**RE: 9 Barnard Rd. Section 108.03, Block 3, Lot 54
GENTILE
Continuation Of Planning Board Site Plan Review**

**Re: 9 Barnard Rd. / Section 108.03 – Block 3 – Lot 54
Continuation for Planning Board Site Development Plan Approval**

This letter accompanies a continuation for Planning Board site plan review for proposed legalization of improvements of the property at 9 Barnard Rd. Additional information has been provided as the result of the Planning Board site visit and Consulting Engineer review.

SITE PLAN
SHED ADDITION AND
STONE RETAINING WALL

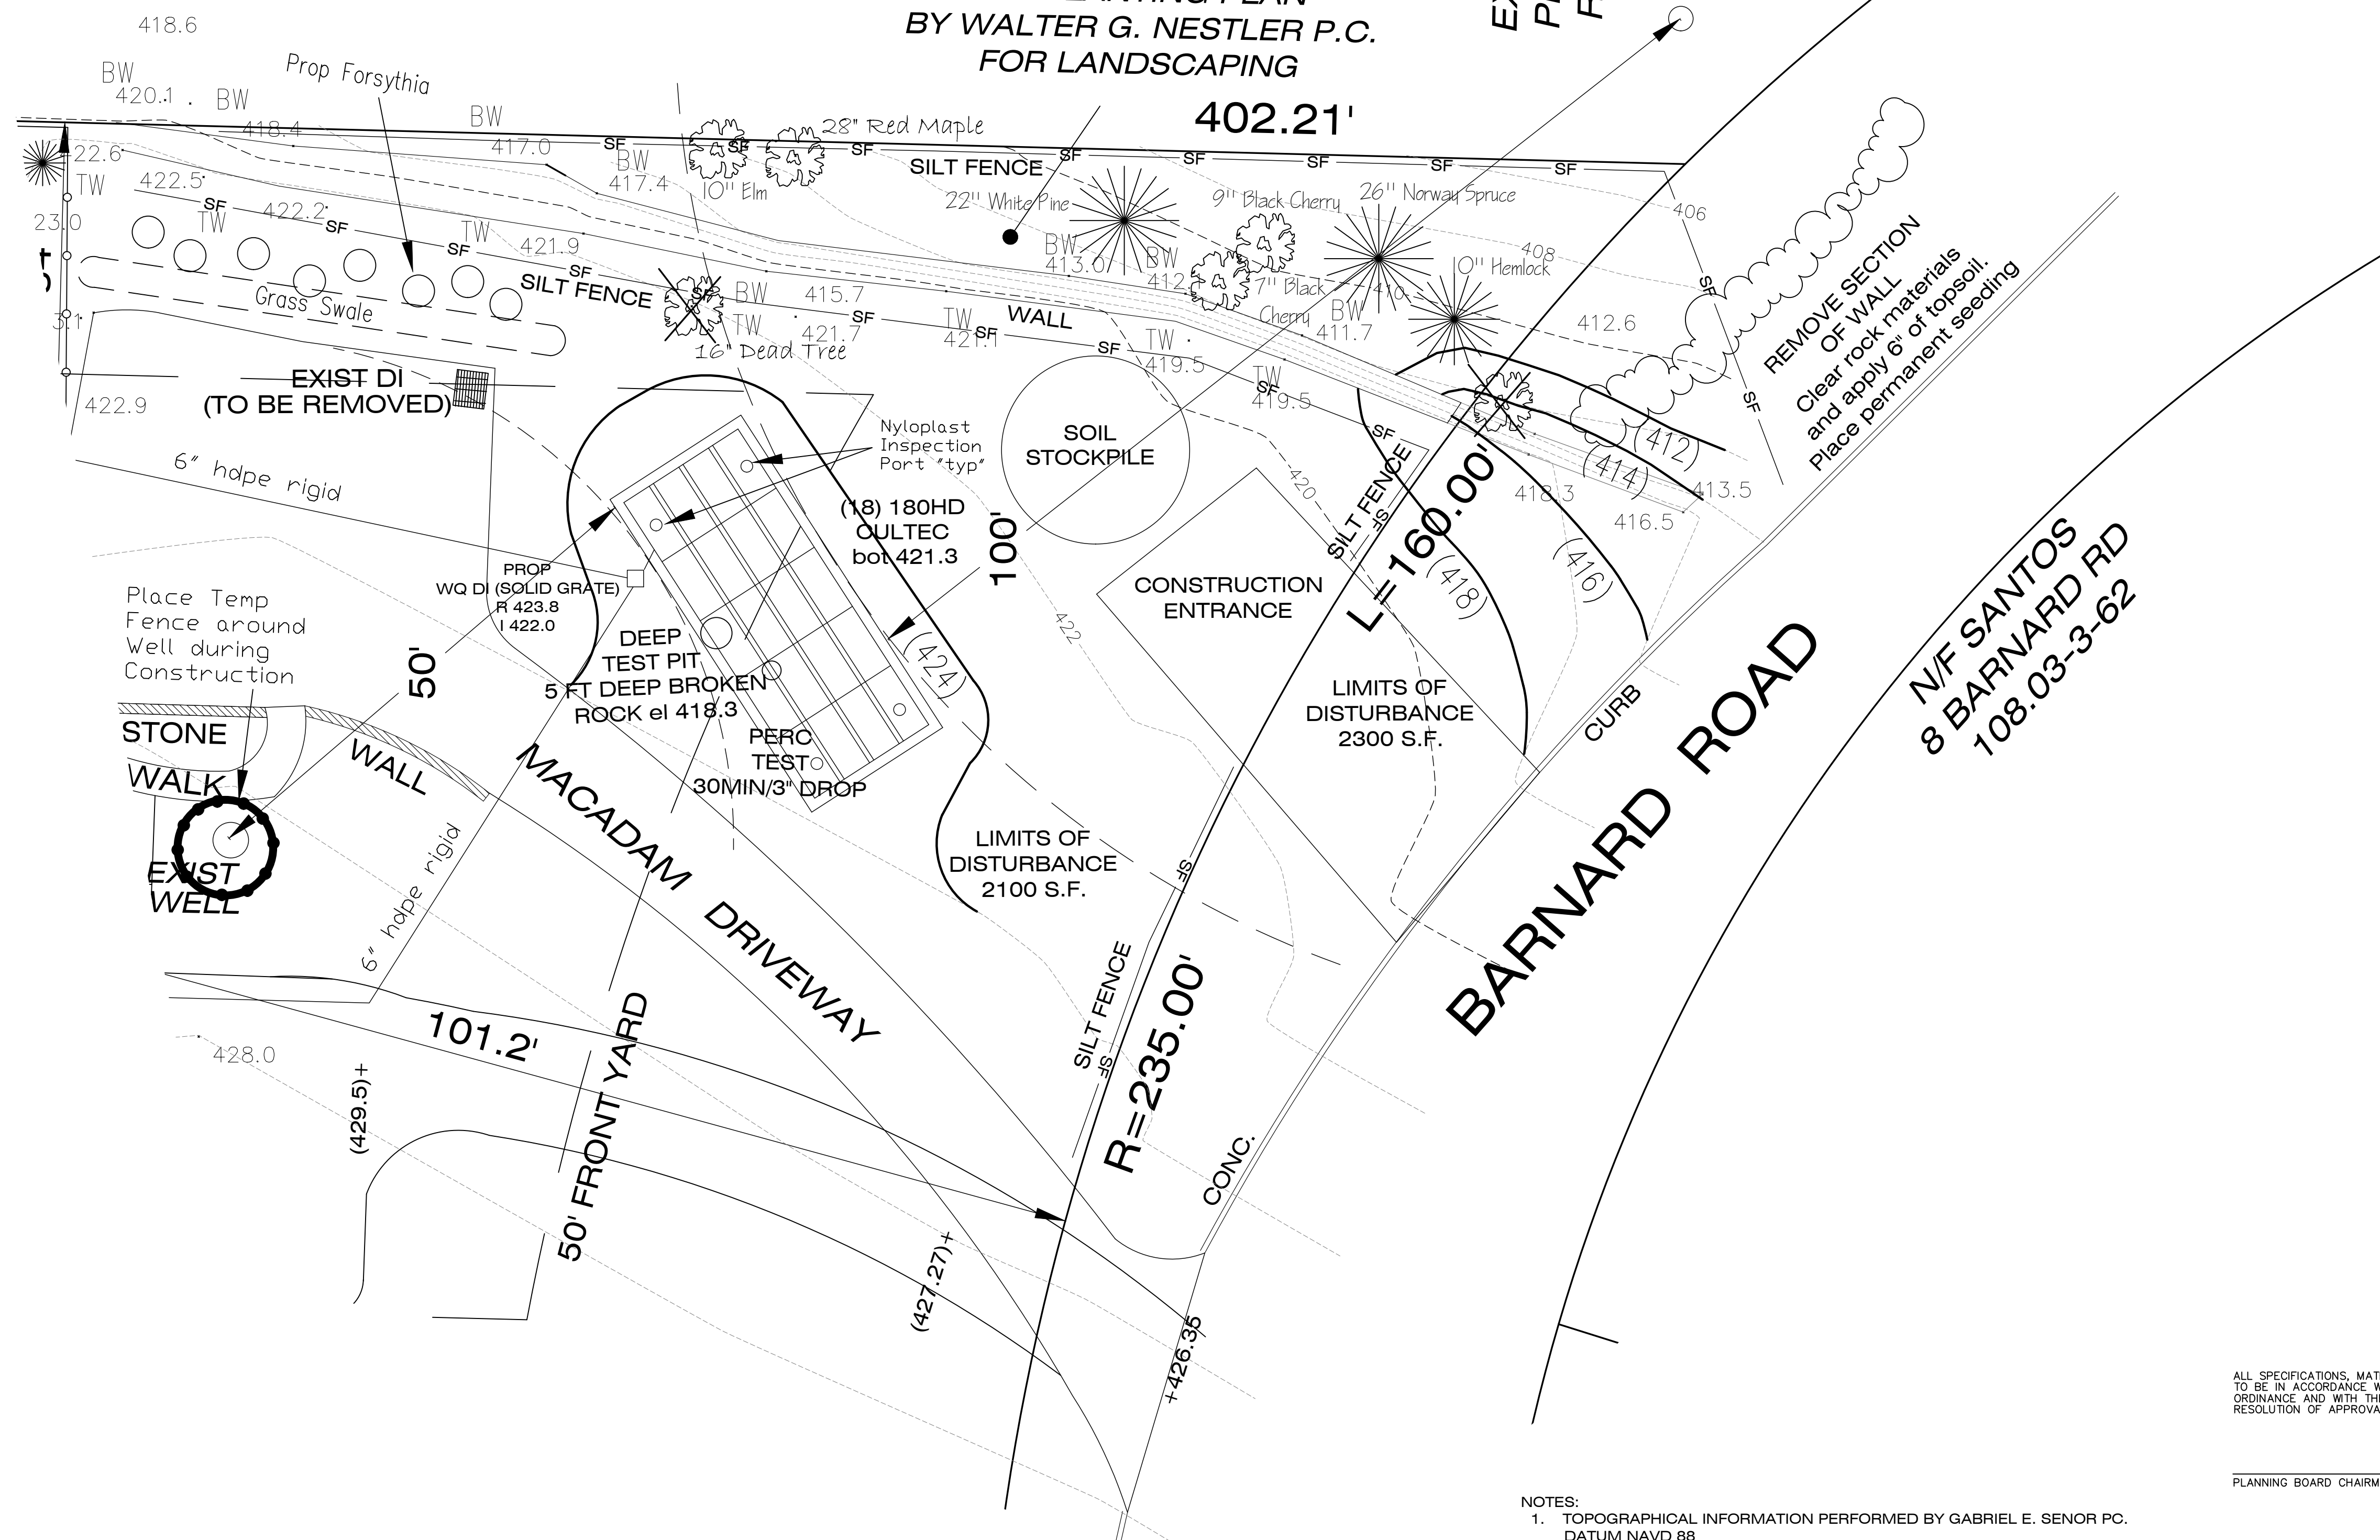
1. The plan shall demonstrate that all required setbacks to the septic, well and stormwater facilities meet minimum WCHD requirements. We note that the domestic well serving the adjacent property to the east is relatively close to the common property line. This well should be survey located and illustrated on the plan to demonstrate that the required separation distance between the well and stormwater management system can be maintained.

4. The plan illustrates an existing stone retaining wall along the eastern property line at the front of the site. This wall was constructed without prior approval and exceeds six (6) feet in height. This office is not aware of any prior design or construction certification nor was this office able to inspect its construction. Portions of the wall had been constructed within the Town right-of-way and are now proposed to be removed and the area restored. We offer the following comment relative to the wall:

- The limits of the wall to be removed within the Town right-of-way are illustrated on the plan. The plan shall also illustrate and detail the means to restore this area.

- As previously requested, the applicant shall provide an estimate of the quantity of fill imported to the site to construct and backfill the wall. As part of this estimate and based on a field visit attended by this office and the Building Inspector during the prior application, it appeared that fill was also imported to regrade a portion of the rear yard. This assumption was supported by review of available Westchester County GIS data and the buried "feet" of existing trees in the rear yard. This added material should be included in any cut/fill calculation.

- The Stone Wall Detail illustrates a tiered retaining wall with a maximum height of four (4) feet. The existing retaining wall is not dimensioned on the detail. However, based on field visits, the wall reaches heights of approximately eight (8) feet. The lower tiered wall does not dimension the footing width or depth of crushed stone backfill. The retaining wall design and detail shall be updated accordingly. When the original wall was first constructed, and as part of the prior application, the applicant was required to provide a design certification by a New York State Licensed Professional Engineer demonstrating that the wall, as constructed, is stable, has been adequately sized to provide appropriate factors of safety for sliding, overturning and bearing, and has been constructed in accordance with the design and detail. Said certification was not received by this office. It is not clear why the lower retaining wall is required or being proposed at this time. We assume that the plan to construct a second tier with a maximum height of four (4) feet is to eliminate the need to provide the above certification. However, the proposed retaining wall plan will require clearing of whatever vegetated buffer remains along the property line. The Planning Board should consider whether this is appropriate or if the wall should remain as is and the certification be provided.

The plan illustrates a temporary construction access above the existing retaining wall for construction of the infiltration system. The plan must be revised to illustrate how the area of the lower wall will be accessed for construction and what measures will be used to protect the downgradient property from being disturbed. It is not clear how the proposed lower wall can be constructed as proposed without some level of disturbance to the adjoining property.

6. The plan proposes an infiltration system to collect and mitigate stormwater runoff generated from the existing residence and shed. The existing roof leader connection that discharges off site is proposed to be removed. This office previously witnessed soil testing in the vicinity of the practice to demonstrate that suitable soils exist. We note, however, that the depth to rock, as noted on the plan, is approximately five (5) feet. As such, it does not appear that the required 3 ft minimum separation will be provided by the design. The infiltration system layout shall be adjusted accordingly. We would also recommend that an additional inspection port be shown the unit to which the storm piping is connected.

8. Drawing S-2 appears to have been named incorrectly and should be revised to "Proposed Conditions".

Plan development has Health Department Approval. Well information shown as per Health Department records.

Restoration noted on plan. Sediment and Soil Stockpile measures shown.

Approximately 450 cubic yards of fill has been placed behind the wall. The rear yard was regraded and a planting berm was added. It is estimated to be approximately 350 cubic yards.

The construction of the lower wall is no longer under consideration. It was suggested at the Planning Board site visit that the existing wall will remain. A letter of certification to the construction and stability has been provided with this submission.

Storm system has been updated for proper 3 ft. separation.

Drawing S-2 has been revised to "Proposed Conditions"

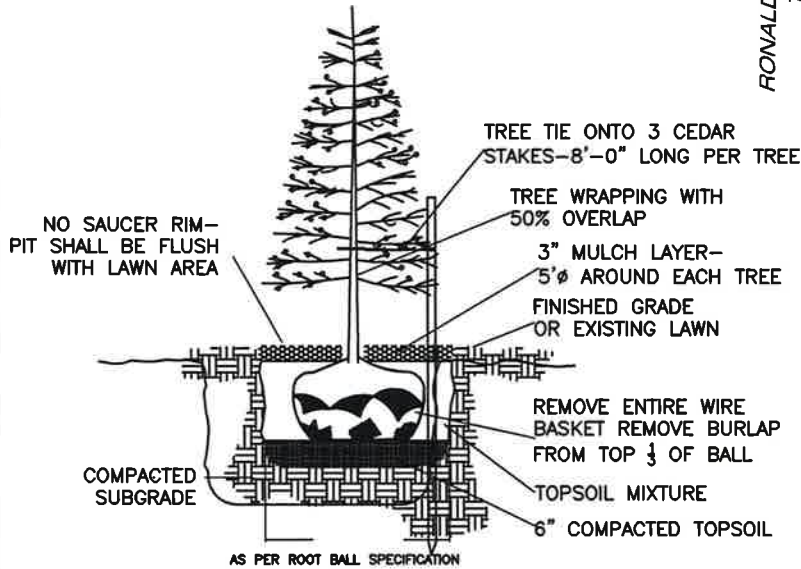
7. The plan proposes to remove the existing drain inlet located within the driveway, which currently discharges to the adjoining property. The plan, however, does not illustrate how runoff from the driveway will be collected or conveyed. Without the inlet, it appears that stormwater runoff will continue to sheet flow toward the adjoining property. The applicant should review this layout and consider an alternative to collect and mitigate this flow. We note that should this drain inlet be connected to the infiltration system, the WCHD minimum required setback to a drilled well is 100 feet.

The existing drain will be removed along with the point discharge. To prevent sheet flow a grass swale will be constructed and additional plantings of Forsythia will be planted.

PLANTING PLAN
GENTILE RESIDENCE
 9 BARNARD ROAD
 ARMONK, NEW YORK 10504

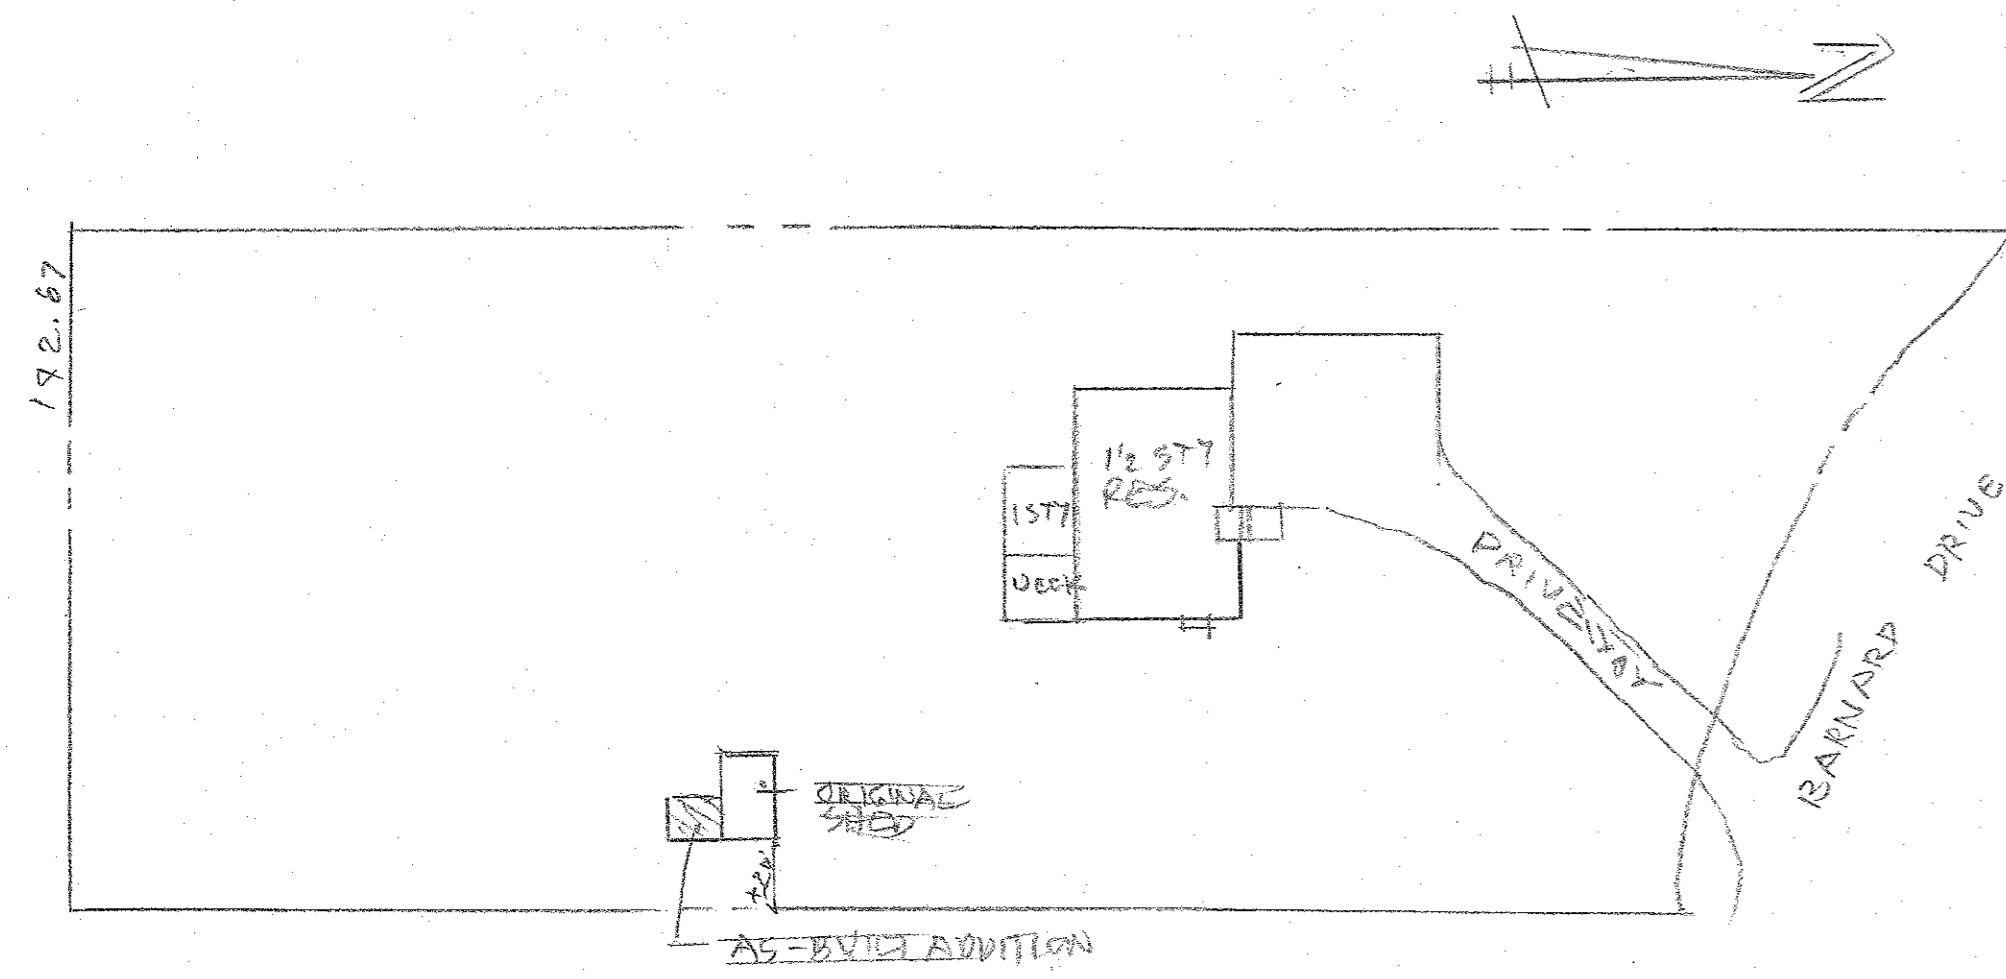
3. The applicant has provided a Landscaping Plan for consideration by the Planning Board. The Site Plan shall depict all Town-regulated trees proposed to be removed or protected within and ten (10) feet beyond the proposed limit of disturbance. It appears that, at a minimum, additional tree removal is required for the proposed lower retaining wall. We note that in addition to the two (2), 20-inch pine trees illustrated on the plan, that there exists a relatively dense vegetated buffer between the adjoining lots. This buffer will require clearing in order to construct the retaining wall. The plan proposes to replant this area with a mix of dwarf junipers and boxwoods. We would recommend that the Planning Board consider requiring a more robust screening plan.

questionable. We note that there is at least one dead tree in the immediate vicinity of the retaining wall (assumed to be the 14" tree illustrated on the plan). This should be confirmed by the applicant. We would recommend that the dead tree be shown to be removed. The Planning Board should discuss whether additional plantings are appropriate.

A landscape plan has been prepared by a landscape architect based upon suggestion by Planning Board. Proposed lower wall no longer being considered.

See Landscape Plan provided.
